Model: PD-D1	Date: 12-Apr-12	No.: RC279001c
--------------	-----------------	----------------

Subject: Firmware Release Note: Main(A3)		Prepared by: Y. Kuwabara	
From: 2nd Tech Service Sect., MFP/Printer Tech Service Dept.			
Classification:	<input type="checkbox"/> Troubleshooting	<input type="checkbox"/> Part information	<input type="checkbox"/> Action required
	<input type="checkbox"/> Mechanical	<input type="checkbox"/> Electrical	<input type="checkbox"/> Service manual revision
	<input type="checkbox"/> Paper path	<input type="checkbox"/> Transmit/receive	<input type="checkbox"/> Retrofit information
	<input type="checkbox"/> Product Safety	<input checked="" type="checkbox"/> Other (Firmware)	<input checked="" type="checkbox"/> Tier 2

Subject: Exit Pawl Timing Adjustment		Prepared by: K. Yamamoto	
From: 1st Tech Service Sect., MFP/Printer Tech Service Dept.			
Classification:	<input checked="" type="checkbox"/> Troubleshooting	<input type="checkbox"/> Part information	<input type="checkbox"/> Action required
	<input type="checkbox"/> Mechanical	<input type="checkbox"/> Electrical	<input type="checkbox"/> Service manual revision
	<input type="checkbox"/> Paper path	<input typ

Procedure I: Checking whether exit pawl timing is correct

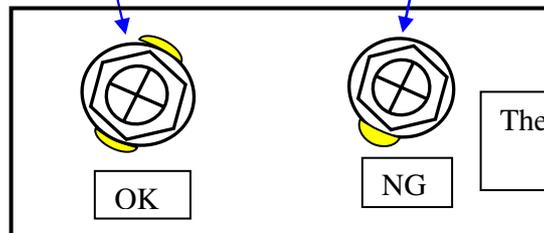
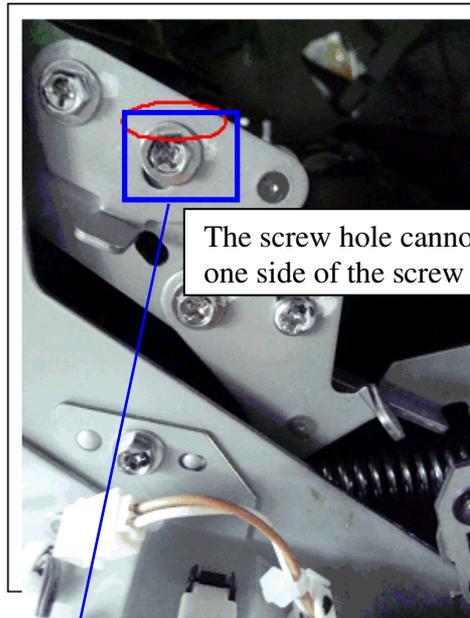
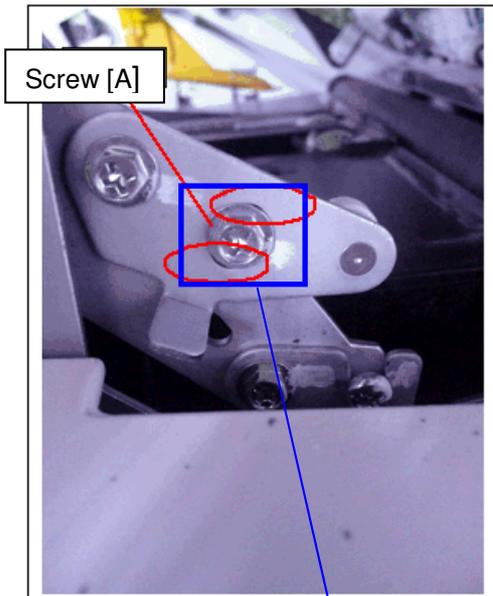
The Exit Pawl might be stuck to the drum during machine installation.

The exit pawl timing was not adjusted correctly at the factory.

1. Pull out the drum from the machine.
2. Check whether you can see the screw hole behind the screw [A].
 - If you **can** see any part of the screw hole, even if only a very small part (shown in yellow in the diagrams below), you **do not need** to do the “Adjusting the exit pawl timing” procedure below.
 - If you cannot see any part of the screw hole, do the procedure below.

The screw hole is shown in yellow

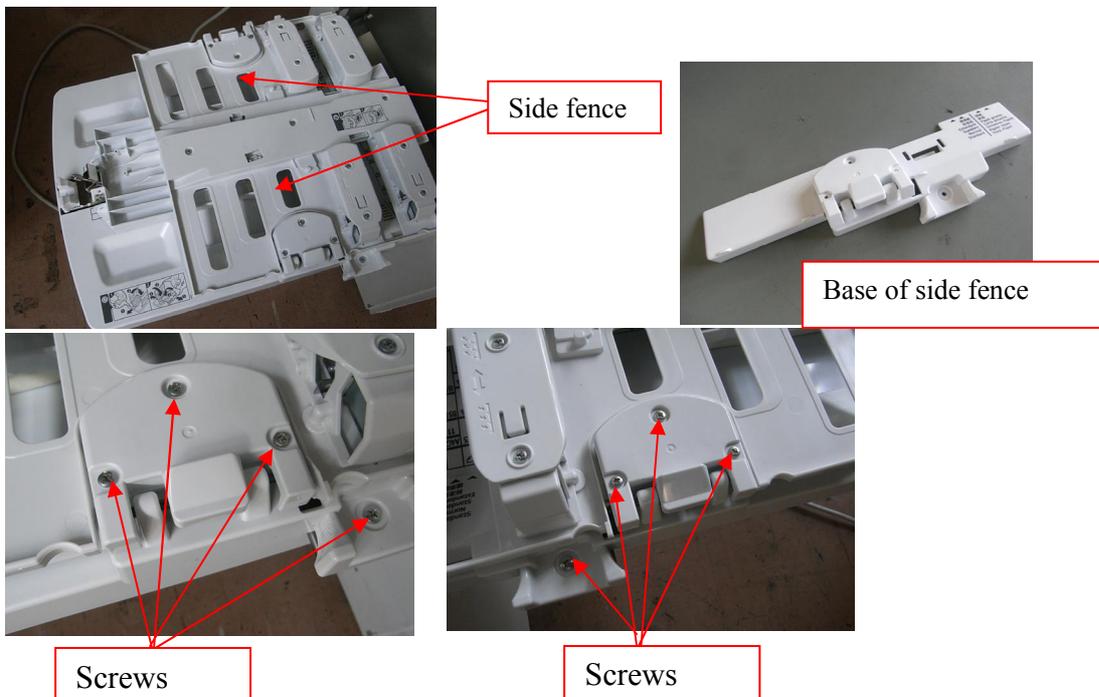
The base of the side fence for the paper exit table might break.

The oil on the shaft of the side fence base reduces the strength of the base (this oil should not be present on the shaft).

Replace the bases of the side fences for the paper exit table (screw x4 front, x4 rear).

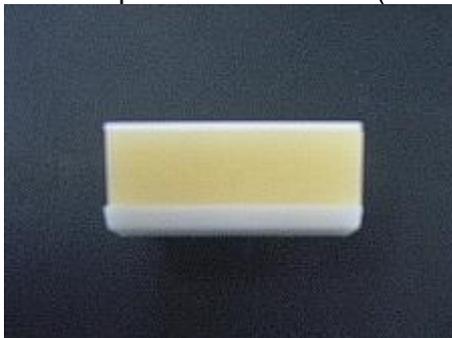
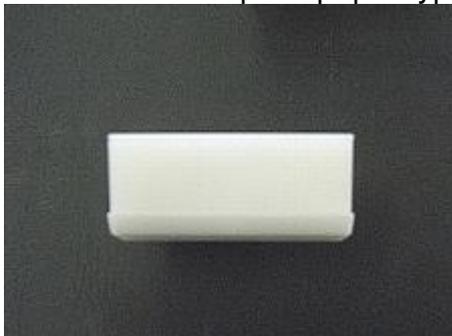
The paper is abraded after contacting the friction pad during paper feed.

The friction of the normal friction pad is too high or too low for some paper types.

If the symptom occurs, replace the friction pad with one of the following types, which are designed to handle a wide range of paper types.

Friction pad 2: **C2649001** (Coefficient of friction is **less than** that of the normal pad)

Friction pad 3: **C2649002** (Coefficient of friction is **even less than** Friction pad 2)

Note: Normal/plain paper types cannot be fed with this friction pad.

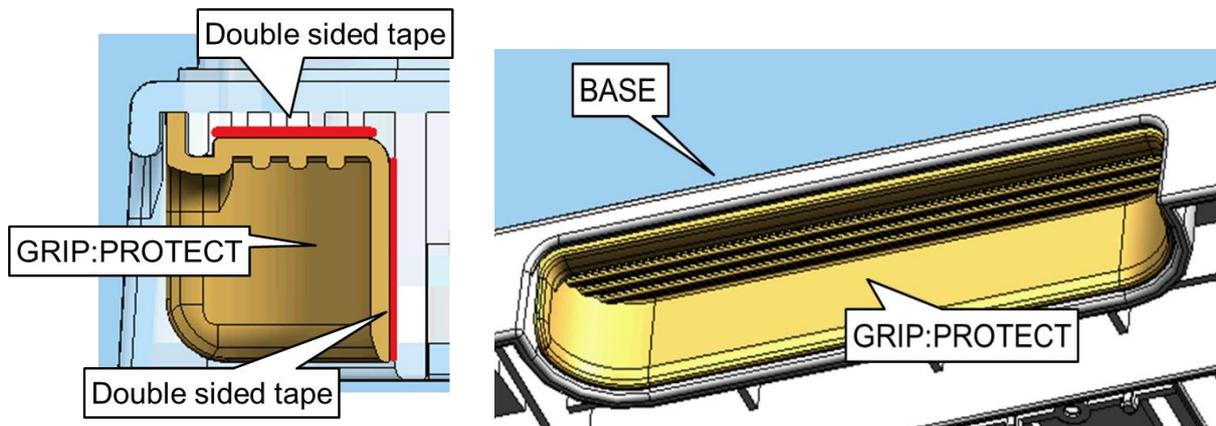
Reason: To increase the adhesive strength between the handgrip and DF base.

Note: The handgrip can be damaged when the DF is opened/closed repeatedly.

Model	Old part number	New part number	Description	Q'ty	Int	Page	Index	Note
LHOTSE-D ARDF 3060	-	D5781991	GRIP:PROTECT:ASS'Y	0-1	-	3	27

Important: Attach the grip to the base using double-sided tape.

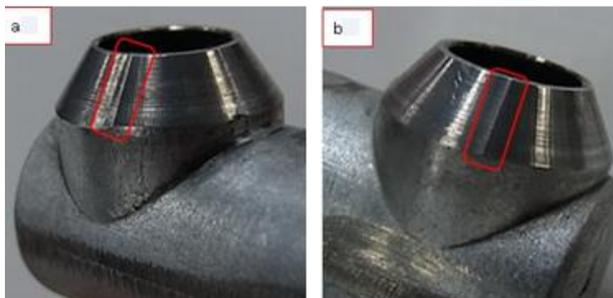
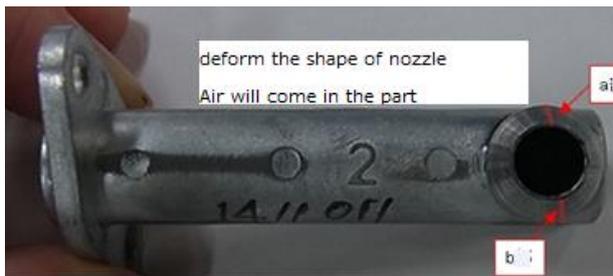
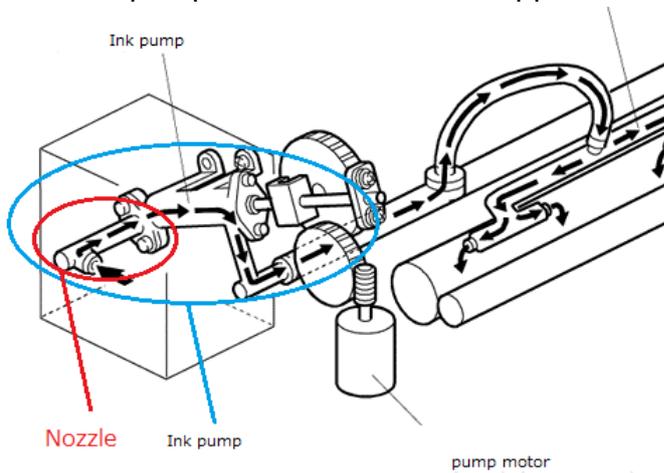
“No ink” is displayed while there is still ink remaining in the ink pack.

The ink nozzle is deformed, preventing a firm fit with the ink pack. As a result, air gets inside the pump and ink cannot be supplied to the machine correctly.
